# HVAC Safety Coordination Meeting

## HI-ECN3/SHiP

*F. Dragoni, N.Zaric/ EN-CV,  
29.11.2024.*

New service building – pressure cascade system

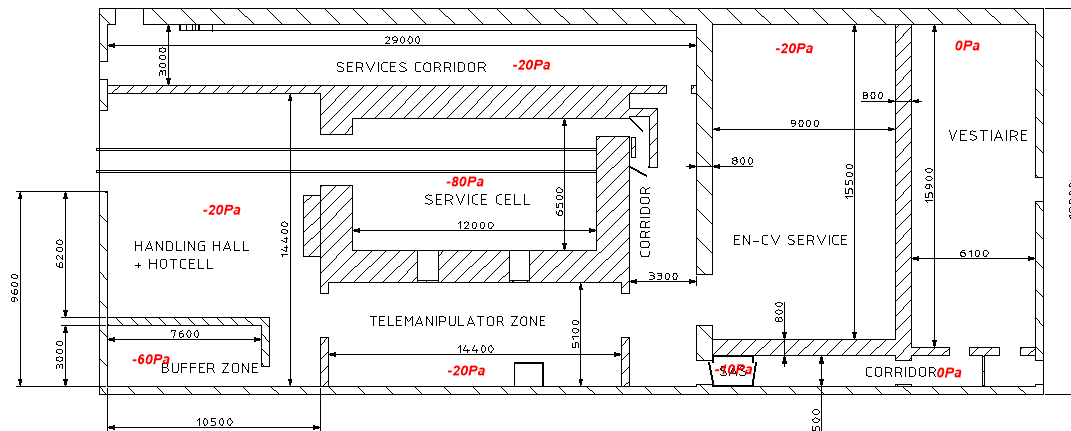
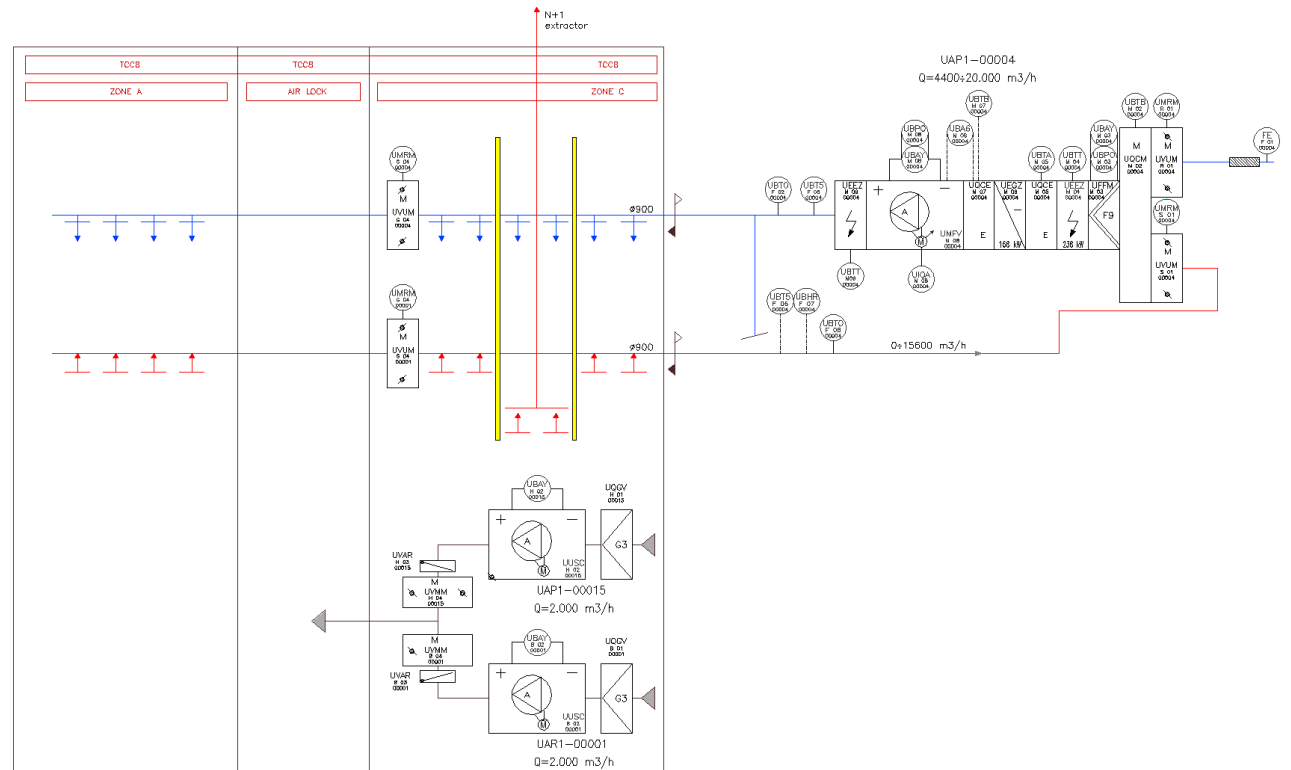
## **Is the values for the underpressure correlated to the class C1, C2, etc? Was there a radiological risk assessment performed to which you based your design?**

- Based on our knowledge, there was no radiological risk assessment

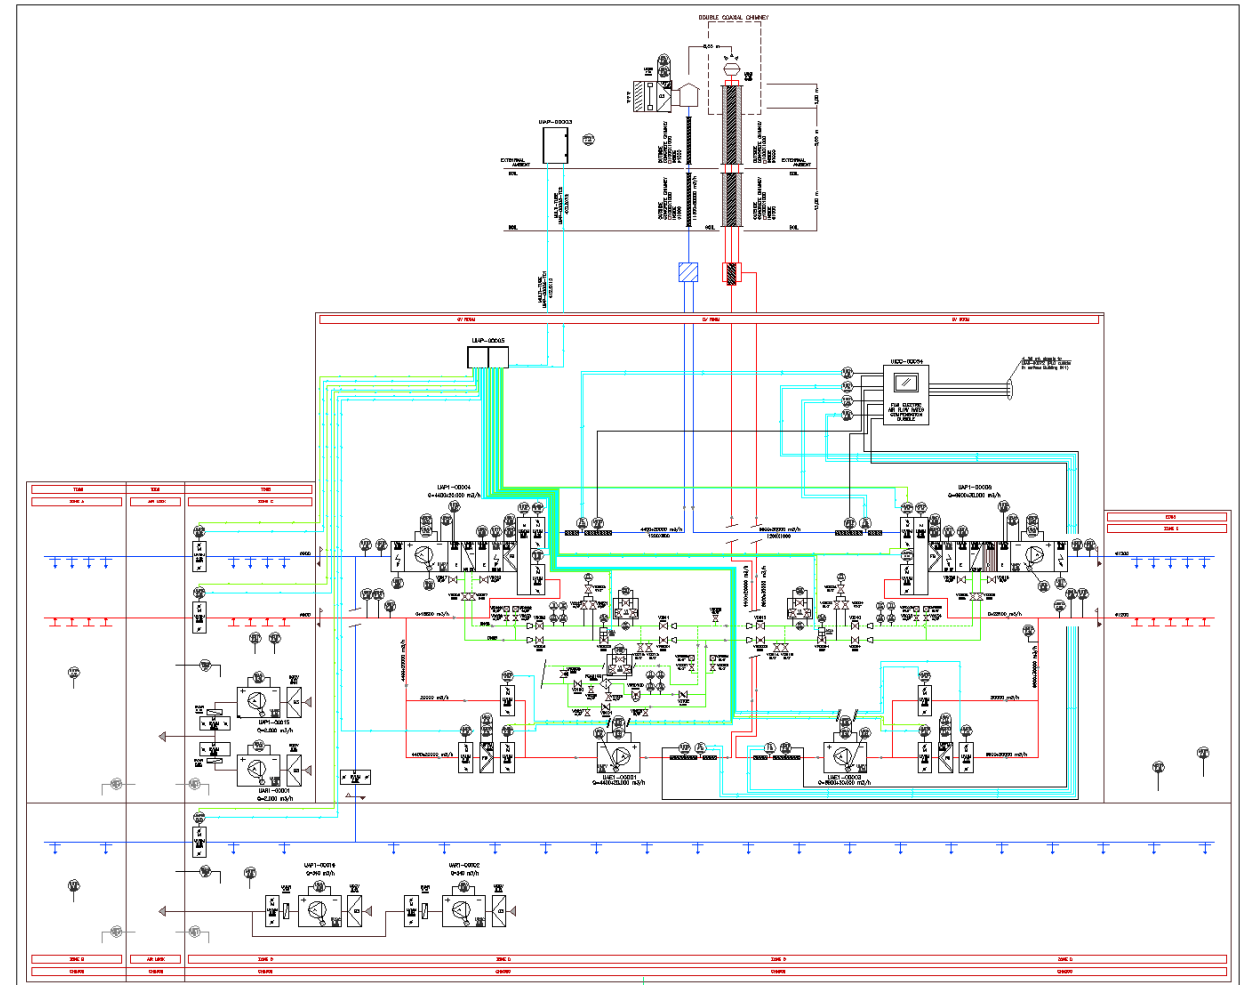
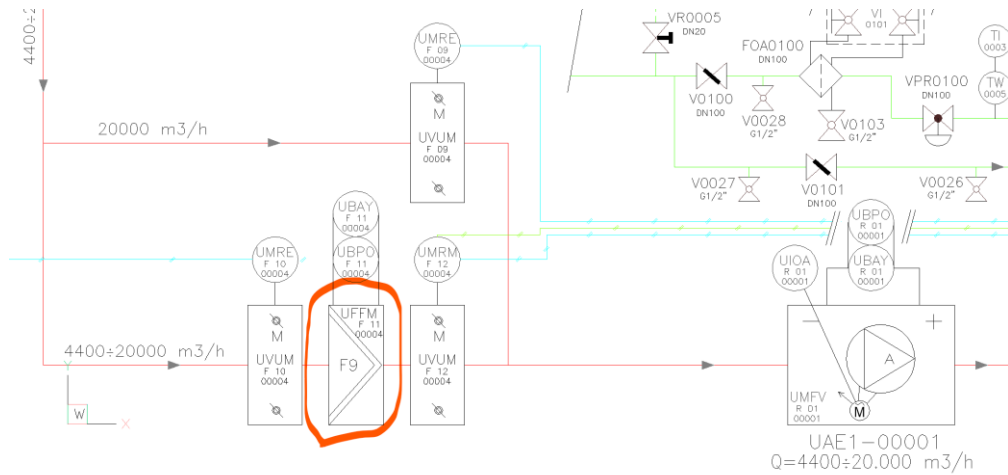
# What type of filtration is foreseen?

- TCC8 & ECN3: current filtration F9

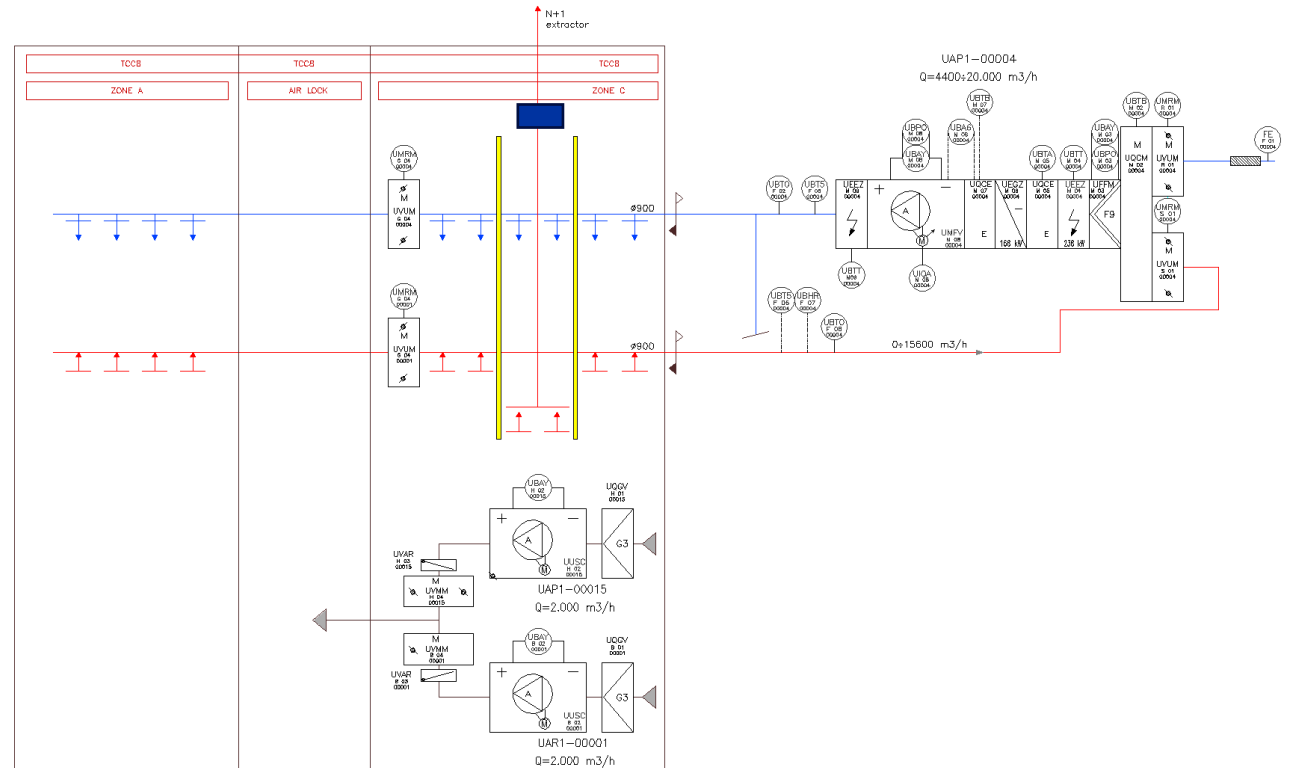
# What type of filtration is foreseen?

- TCC8 new zone: filter type to be seen, could be F9 or any other level

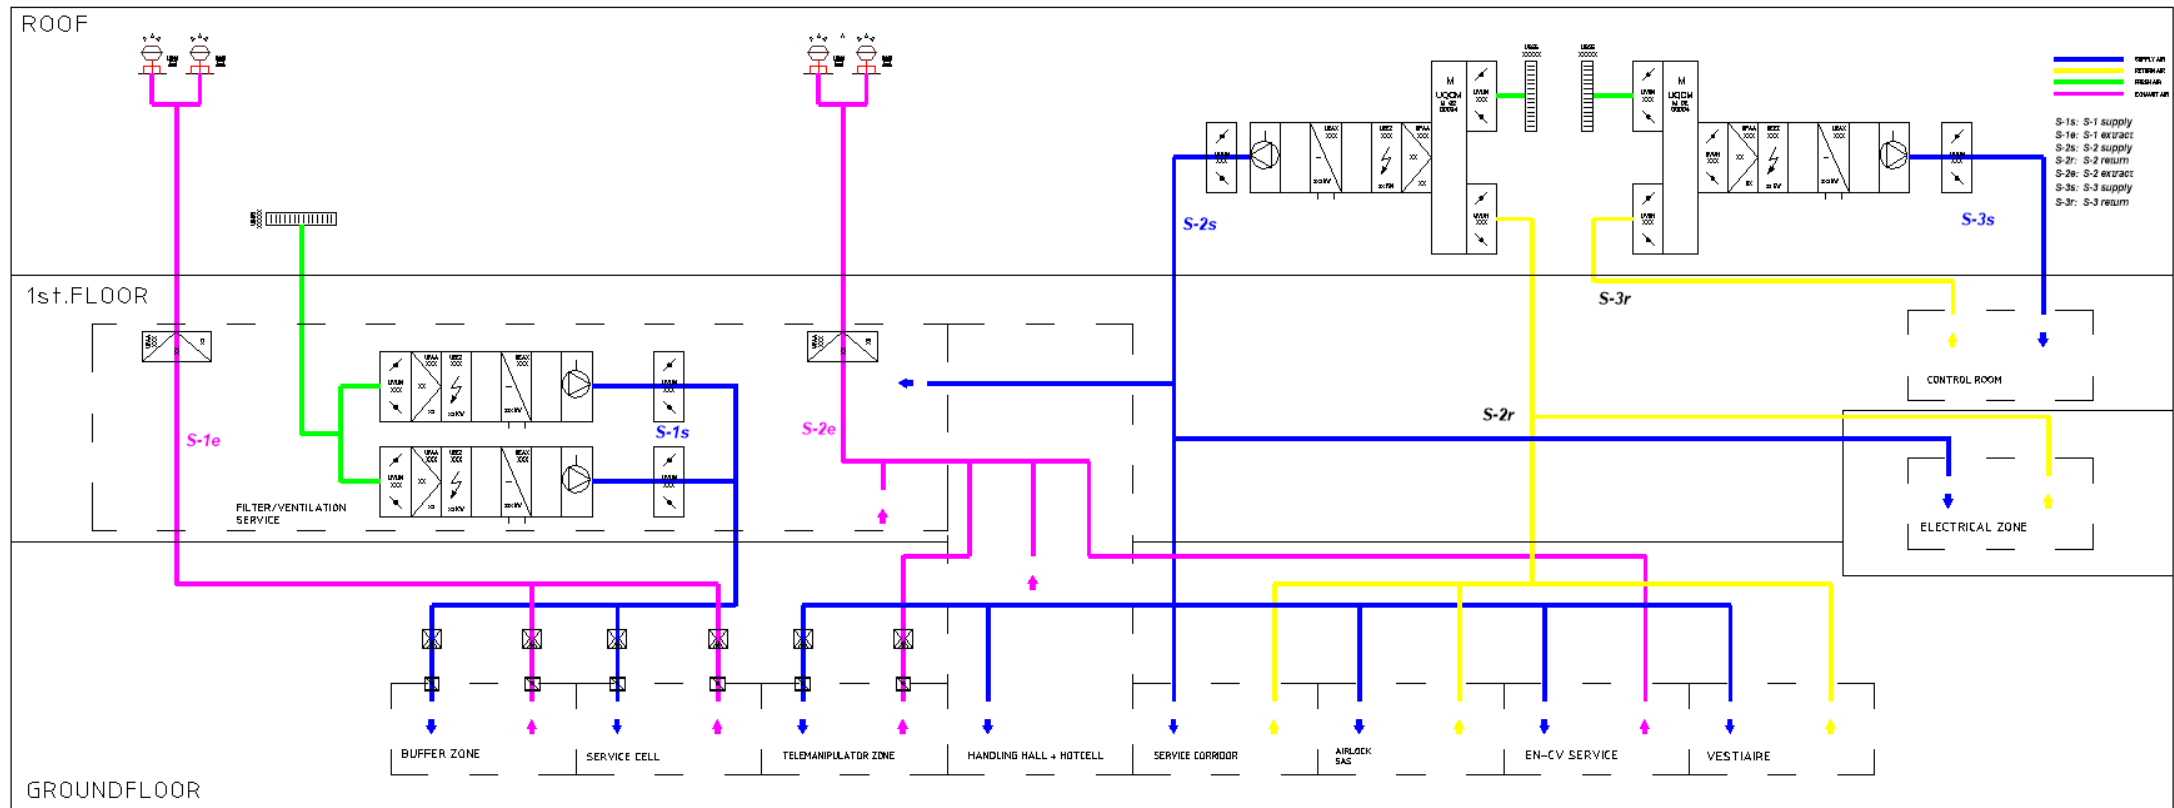
# What type of filtration is foreseen?

- New service building: filtration level not decided yet

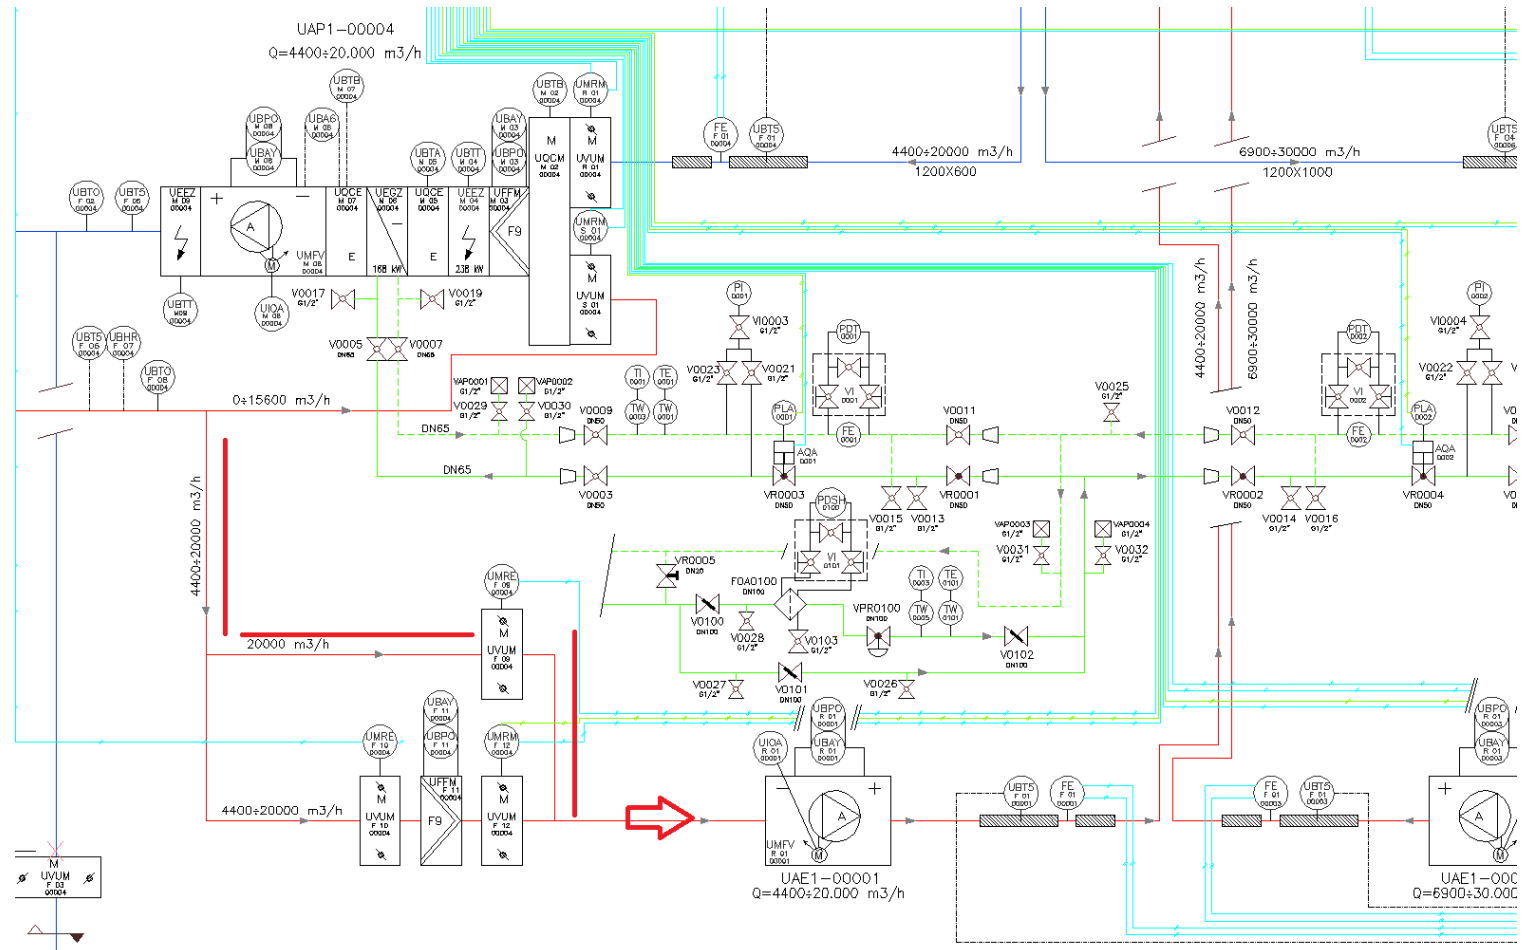
# From the FIRIA studies to we have an idea if smoke extraction is required underground?

- Bypass for the smoke extraction is present in the underground, maximum temperature of air up to 400°C, for 120 min
